The record drawing herein reflects to the best of the design engineer's knowledge, the approximate location of the constructed improvements using information provided by the contractor.

DATE: 12/18/08 HEI #: 08-152

HOMEYER ENGINEERING, INC. - REGISTRATION NO. F-8440

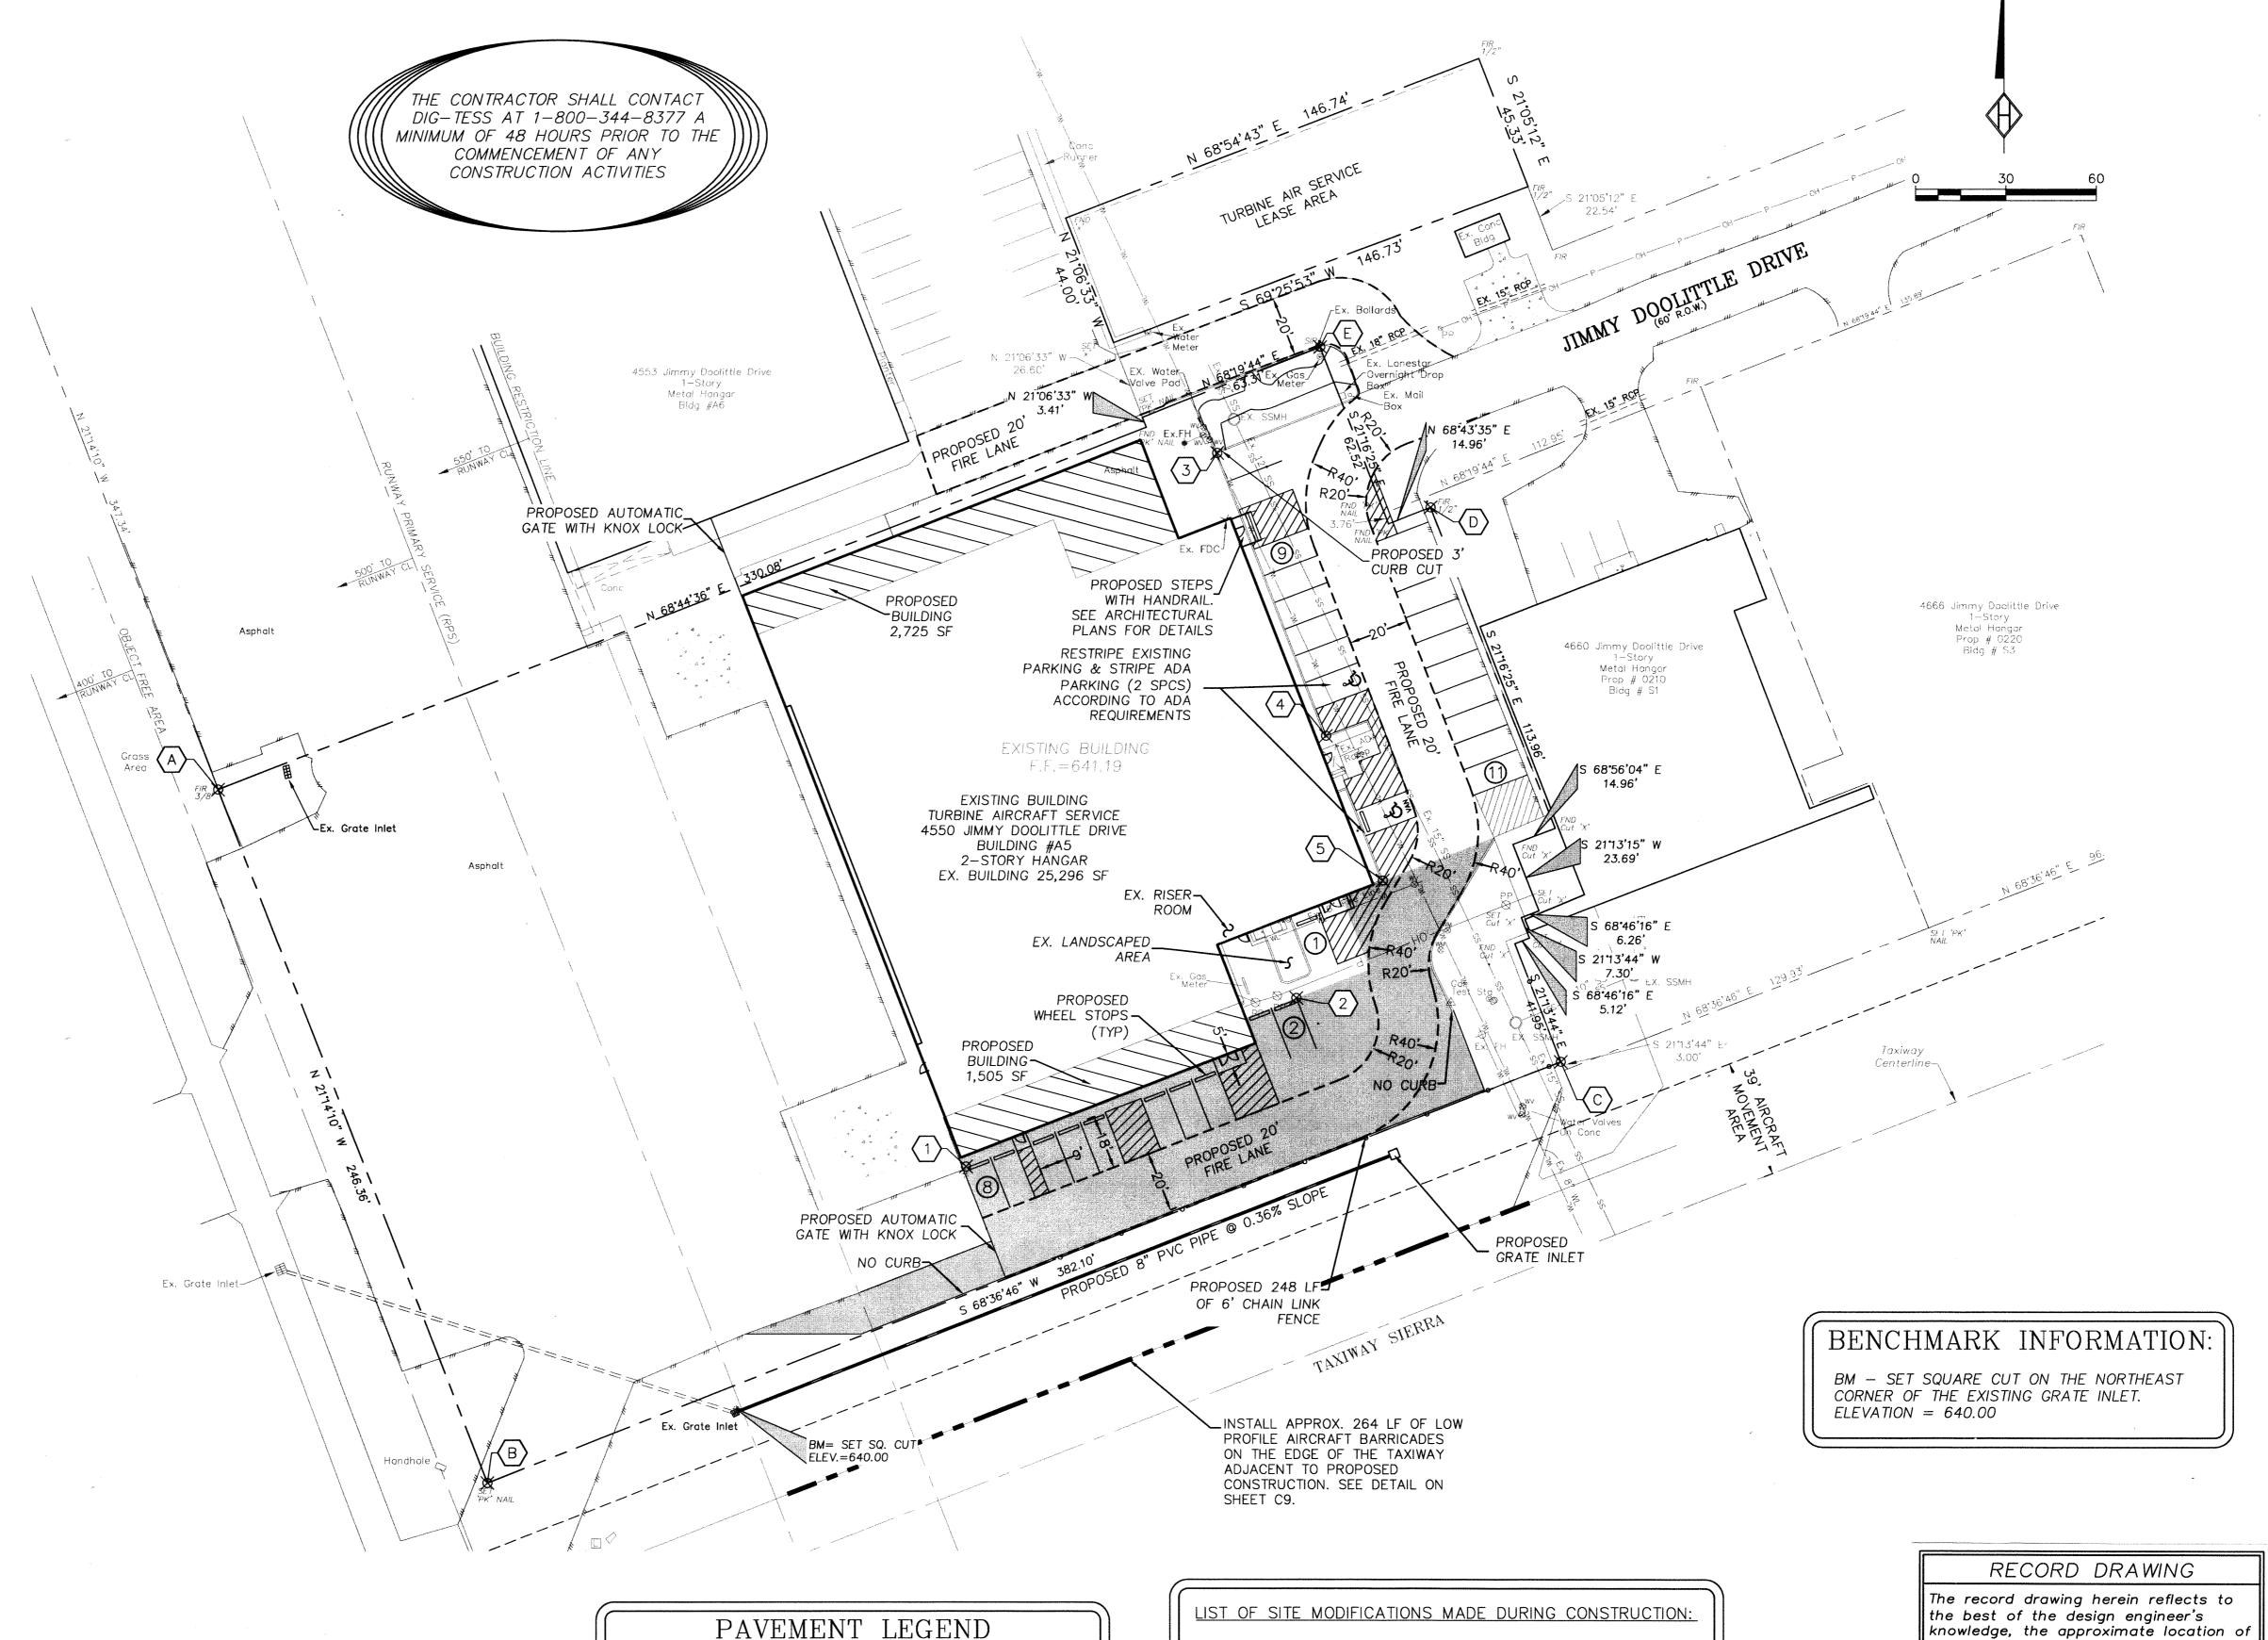
- . REDUCED PROPOSED BUILDING AREA.
- 2. RELOCATED MAIN ENTRY AT NORTHEAST CORNER OF BUILDING.
- RELOCATED ADA PARKING ADJACENT TO EXISTING ADA ENTRY INTO BUILDING.
- REMOVED CURB ALONG SOUTH PARKING AREA AND RAISED THE PROPOSED GRADES.
- 5. RELOCATED VARIOUS PARKING SPACES THROUGHOUT SITE.
- 6. REMOVED 3' CONCRETE FLUME SOUTH OF THE SOUTHERN LEASE LINE.

1. REVISED PLAN TO REFLECT

MODIFICATIONS MADE

DURING CONSTRUCTION.
